CIRCULATE TO:	SERVICE MGR.	PARTS MGR.	MECHANICS	Place in Your "Service Bulletins" Binder
---------------	--------------	------------	-----------	--

- A. II-TR Transmission Testing and Mount Bolt Torque
- B. Drive Unit and Drive Shaft Housing Assembly Gear Ratio Identification
- C. MCM 233 High Tension (H.T.) Lead
- D. New Oil Recommendations for Power Trim Systems
- E. V-Belt Tension Requirements - 1976 Model MerCruiser Engines

A. II-TR TRANSMISSION TESTING and MOUNT BOLT TORQUE

Figure 1. Elbow Installed in Control Valve Housing

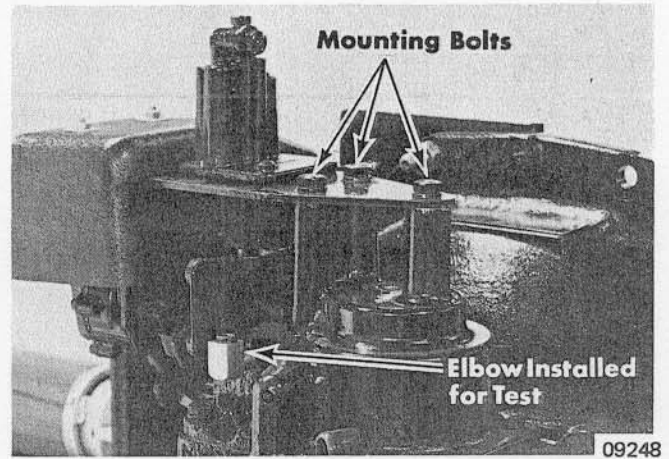
1. To check II-TR transmission oil pressure, install elbow C-22-54035 in control valve housing, as shown in Figure 1. Coat threads with Loctite Hydraulic Sealant (C-92-69917-1). Tighten elbow to face-up position.

Install any pressure gauge that is adaptable. Oil pressure at 750 RPM should be 80 to 105 psi (5.62 to 7.38kg/cm²) and should not vary more than 5 psi (.35kg/cm²) between forward, neutral and reverse after pressure is stabilized in each gear (until needle on gauge is steady). After test is completed, install plug (which was removed from control valve housing) into elbow. Coat threads with Loctite Hydraulic Sealant to prevent leaks.

2. Mounting bolts, shown in Figure 1, must be torqued to 125-135 in. lbs. (144-156kg-cm). If shift bracket bolts become loose, shifting will be affected and possible transmission failure may occur.
